## PLAN REVIEW SHEET

**Petition:** 2012-011

**Attachments:** **Waiting Pad Spec. 60.04A**

**WAITING PAD WITH 5'X15' BOX SHELTER  
WITH PLANTING STRIP**

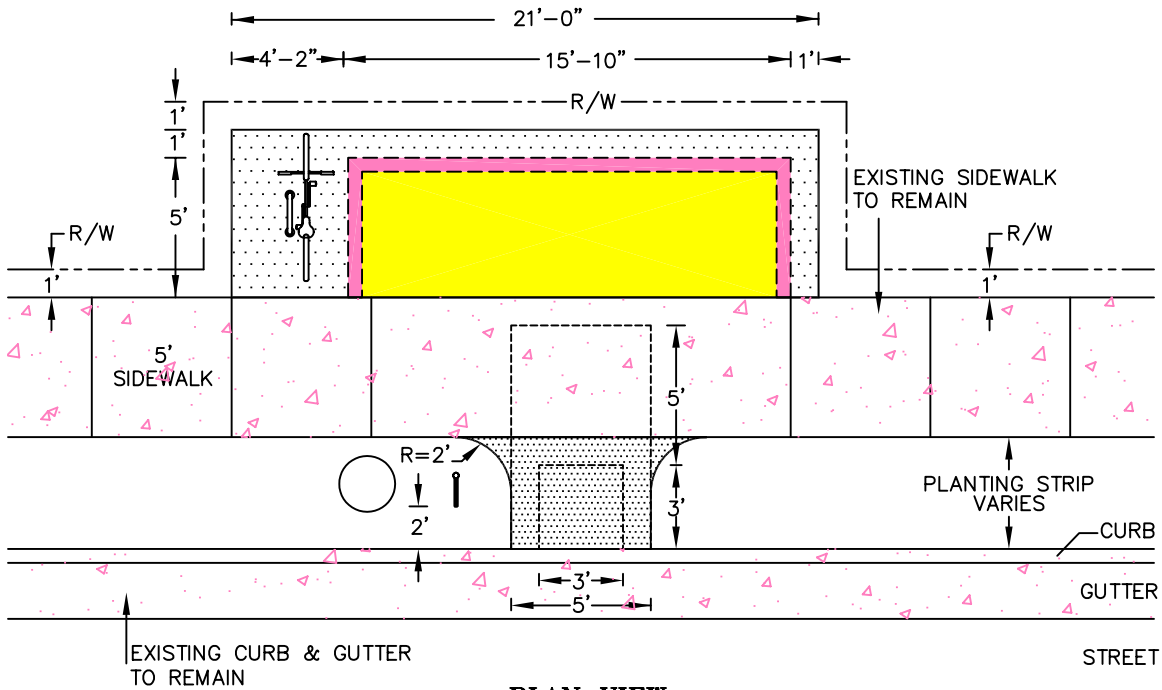
CATS requests that the Petitioner provide a concrete waiting pad as shown on the attached specification. Please contact Budd Early at CATS (704.432.2557) if there are any questions regarding this request. Thank you.
